UNITED STATES PATENT AND TRADEMARK OFFICE

APPLICATION NO.	FILING DATE	FIRST NAMED INVENTOR	ATTORNEY DOCKET NO.	CONFIRMATION NO.
10/075,858	02/13/2002	Carlo Desinano	1011-376	9431

Office Action Summary

DETAILED ACTION

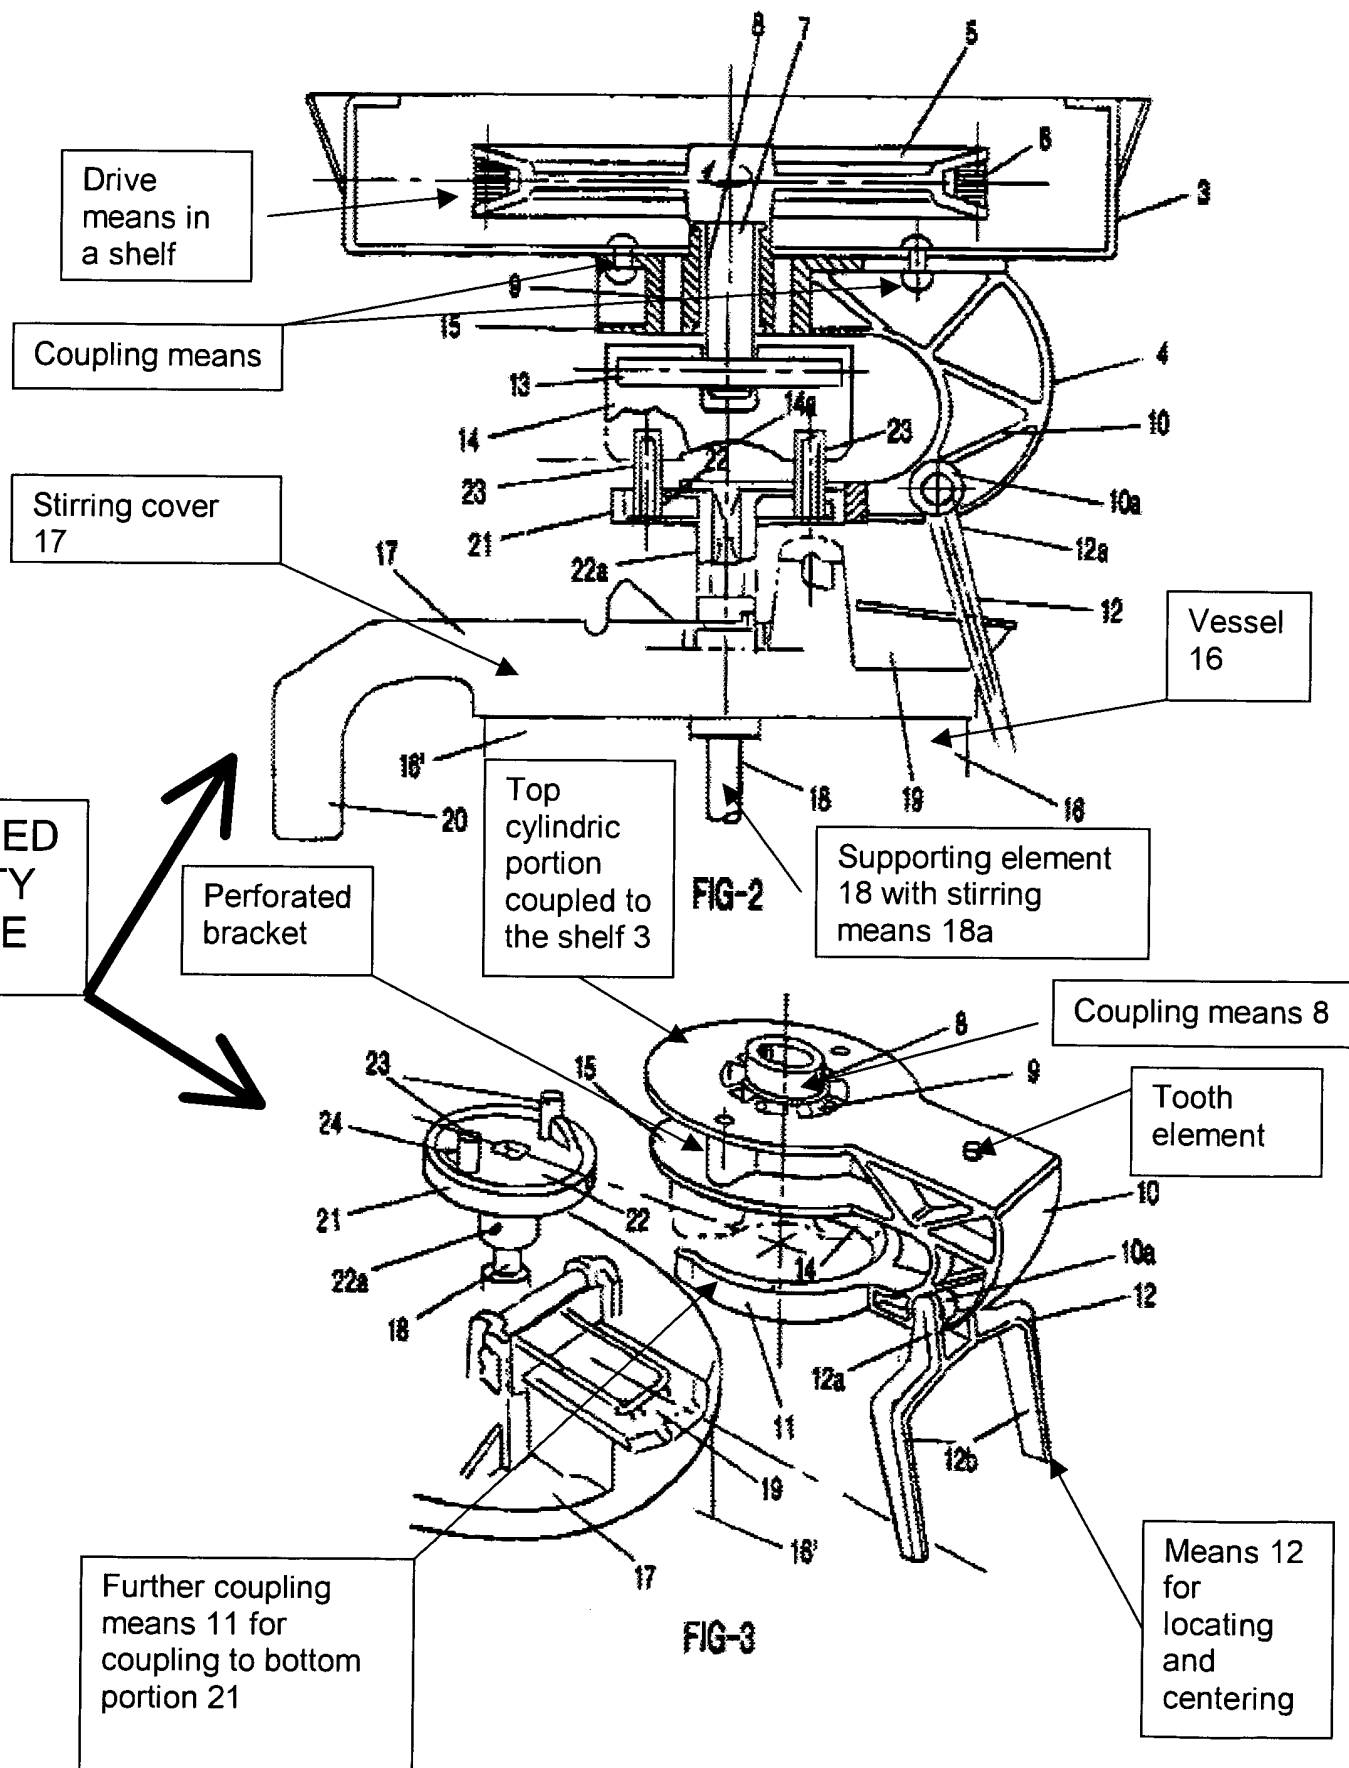
8. Claims 1-2 are rejected under 35 U.S.C. 102(b) as being anticipated by Lesimple (US 5,800,057) as outlined below:

9. Accordingly, as outlined above, the patent to Lesimple discloses the recited elements of the claimed safety device subcombination in a shelved stirring paint vessel environment including top portion 9 having coupling means 8 and coupling means identified in Fig. 2 for coupling the top portion to shelf 3 having drive means 6 therein; means 12 for locating and centering the stirring cover 17; further coupling means 11 for coupling to a bottom portion 21; the top portion having a cylindric portion identified in Fig. 3 having an upper part with a tooth element identified in Fig. 3; a perforated bracket identified in Fig. 3 for attaching the top portion to the shelf.
